**MINOR VARIANCE APPLICATION
COMMENTS TO THE COMMITTEE OF ADJUSTMENT
PANEL 2**

Site Address: 1919, 1967 Riverside Drive
Legal Description: Part of Lots 15 and 16, Concession Junction Gore and Part of Road Allowance between Lots 15 and 16 Concession Junction Gore (Closed by By-Law 174-88, Inst. N451929) Geographic Township of Gloucester.
File No.: D08-02-23/A-00131
Report Date: June 29, 2023
Hearing Date: July 4, 2023
Planner: Justin Grift
Official Plan Designation: Outer Urban, Neighbourhood, Evolving Overlay
Zoning: I2 F(1.0)

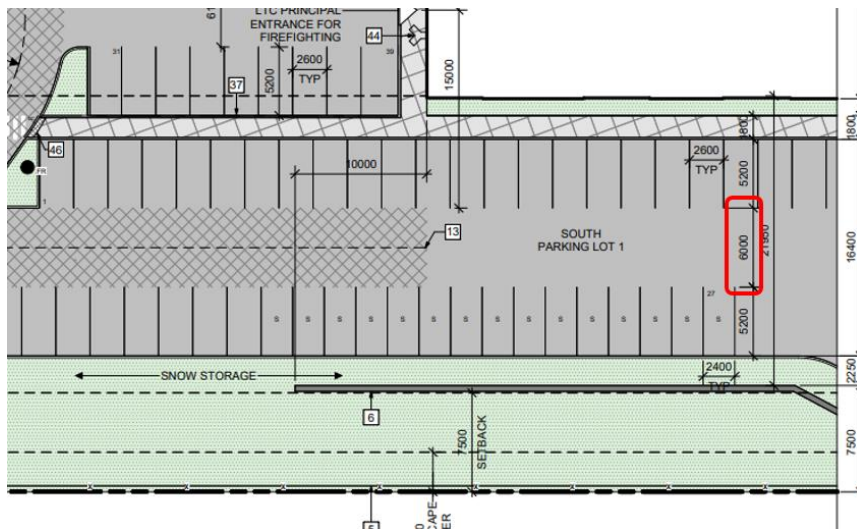
As seen in the plans provided, the applicant is proposing compact parking spaces in several of the new parking lots on the site. However, in the East Parking Lot 2, all 65 of the parking spaces are proposed to be compact car spaces and reduced from the standard parking dimensions in the Zoning By-law. The applicant is seeking relief to have 100% of the parking lot as 'compact car' spaces.

Staff does not have concerns with requested variances e and f. Considering there are a total of 311 new parking spaces being provided in the development and less than 120 that will be 'compact car' spaces, Staff is of the opinion the intent of the Zoning By-law is being met and there are still adequate amounts of standard sized parking spaces to access on site. Further, the applicant has confirmed that East Parking Lot 2 will be reserved entirely for on-site staff parking and will not be available for visitors. Therefore, the East Parking Lot 2 will have a management component that could mitigate any issues with standard-sized vehicles attempting to park on this lot.
